# MAINTENANCE BULLETIN

AN/TPQ-37 (V)4 ANTENNA TRANSCEIVER GROUP	FILE NO: 142	REVISION:
	DATE: 11/13/91	CATEGORY: D-SAFETY
SUBJECT: BACKSHELL / SHIELD INSTALLATION ON BSU AND RECEIVER/EXCITER POWER SUPPLY CONNECTORS	SYSTEMS AFFECTED: SN 89-99 (FMS ONLY)

SUBJECT: Contract DAAB07-87-C-T037  
Resolution of Connector Insulation Issue for  
AN/TPQ-37 Radars SN 89-99

Backshell Installation.

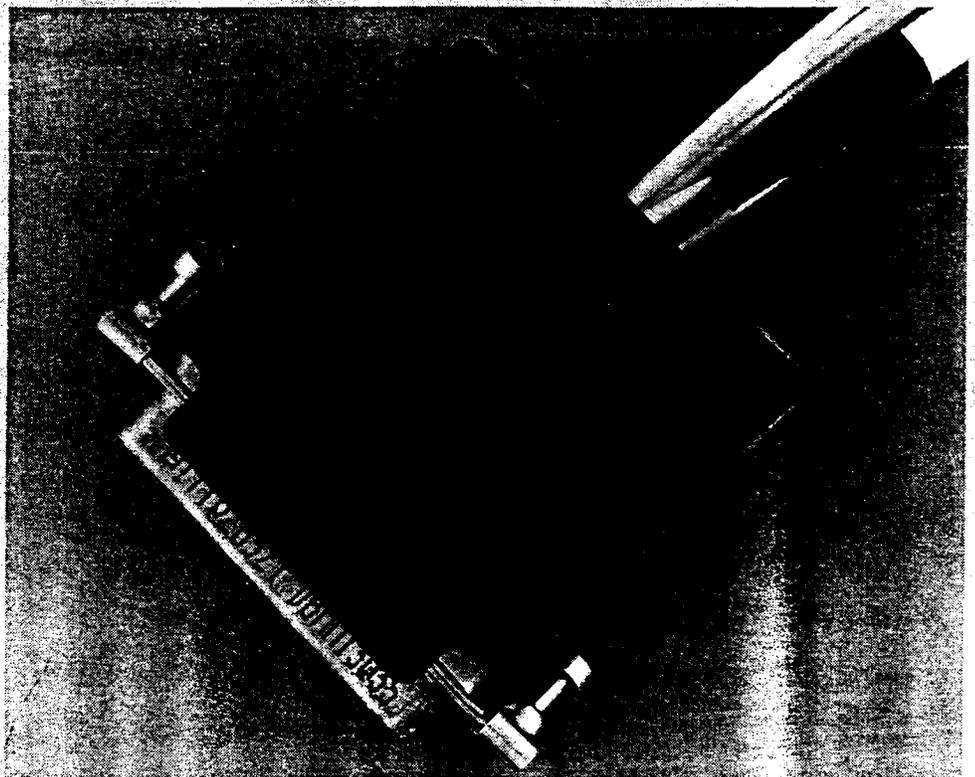
1. Using one half of the two piece backshell, redress wires as necessary to neatly fit within the perimeter of the backshell. Caution is necessary to prevent damage to the wire conductor or insulation.
2. Mate the two backshell halves with the connector and wire positioned as shown. Be certain that none of the wires are pinched between the two backshell halves.

3. Secure the backshell halves by pressing the two halves together until the locking tabs snap in place.

Shield Installation.

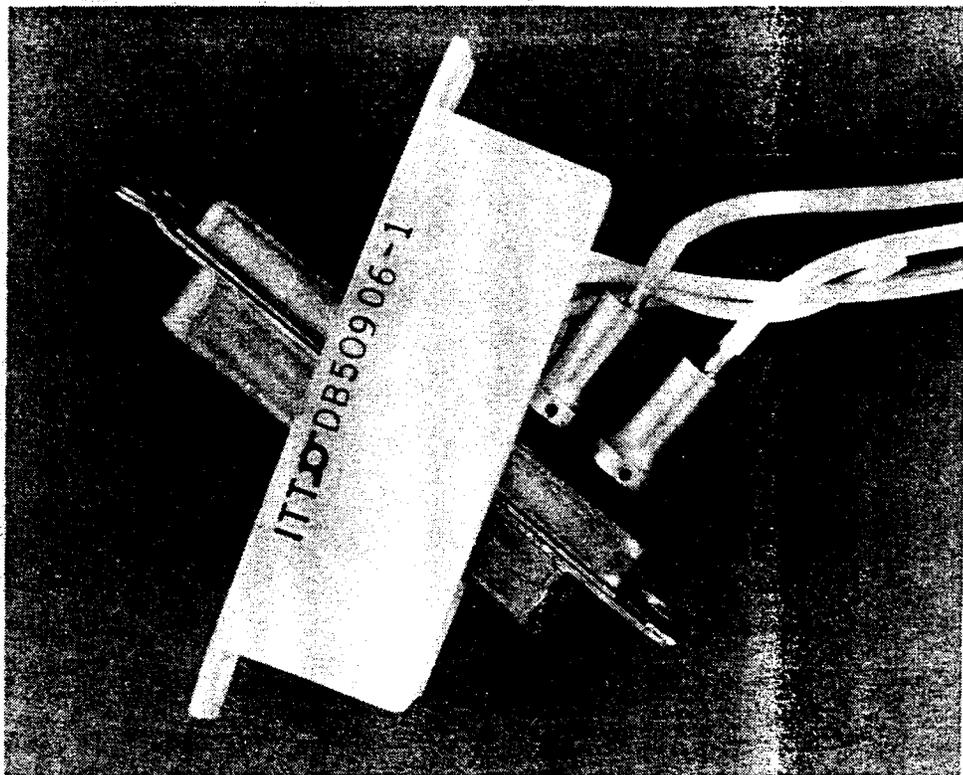
1. Remove the connector retaining assemblies by backing out the retaining screws until the clip portion may be slid off the ends of the connector. Do not discard the retaining assemblies.

2. Starting at one end of the connector, work the shield over the connector and onto the wire bundle. Caution is necessary to prevent damage to the wire conductor or insulation. Tie wraps may be removed from the wire bundle to improve flexibility.

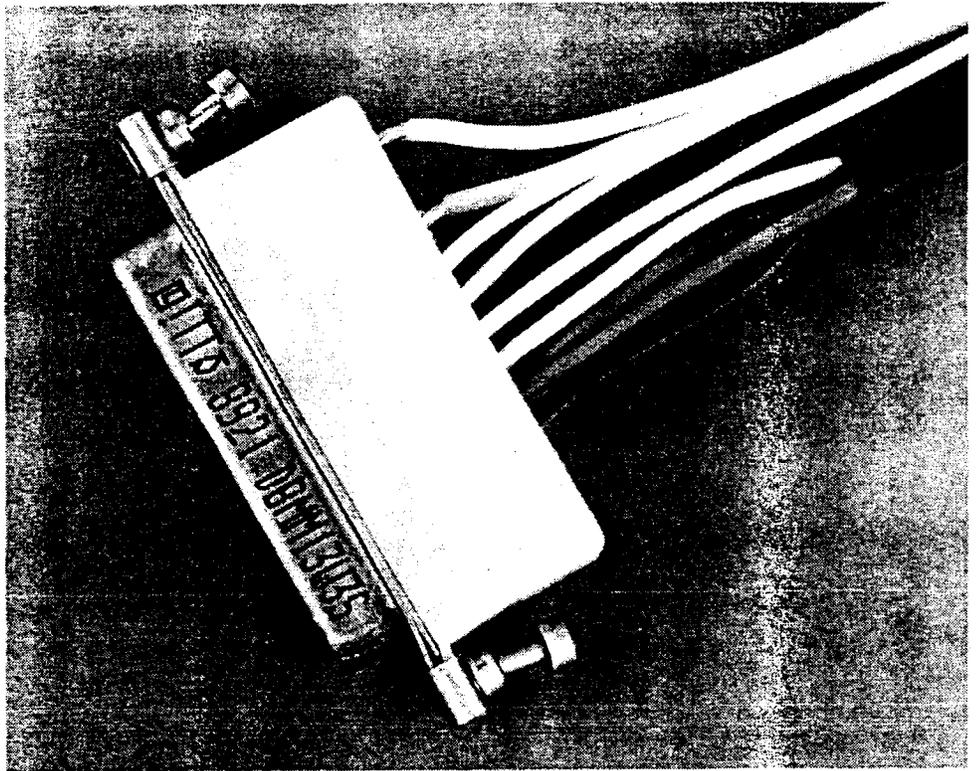
3. Position the shield over the back of the connector and press into place. Be certain to orient the "D" pattern in the shield to match the connector.

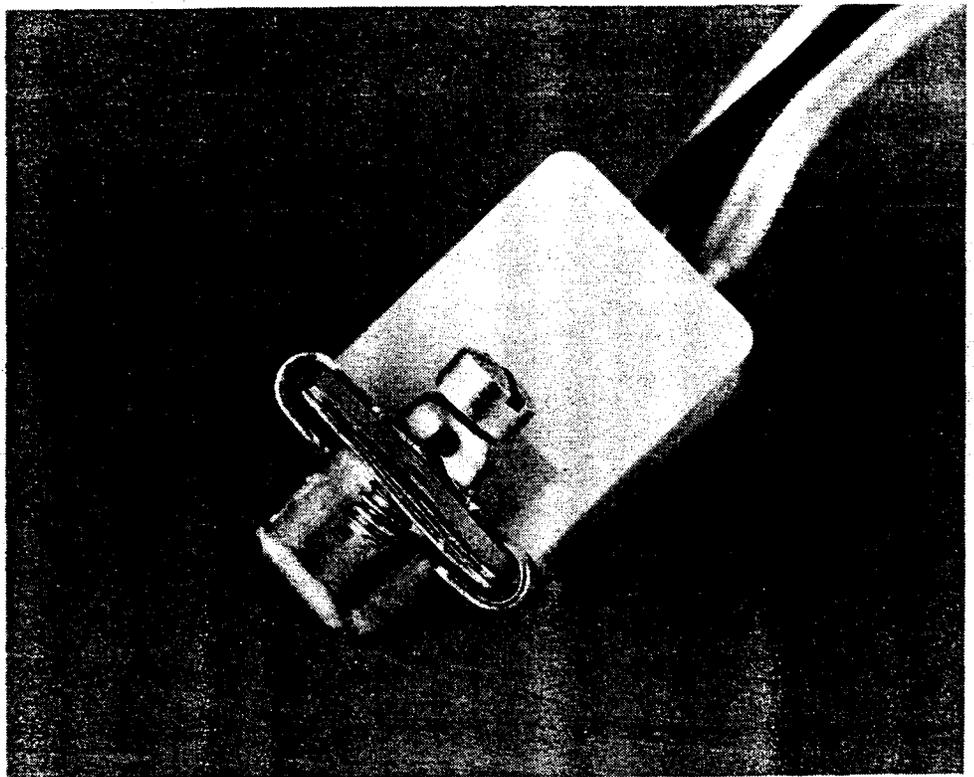
4. Re-install the connector retaining assemblies by sliding the clip portion over the ends of the connector and connector shield. Align the clip, connector, and connector shield so that the screw may pass through the holes provided. The clip portion must capture both the connector and connector shield.

**NOTE:** The clip ends may have to be reformed slightly to accommodate the additional thickness of the connector shield.
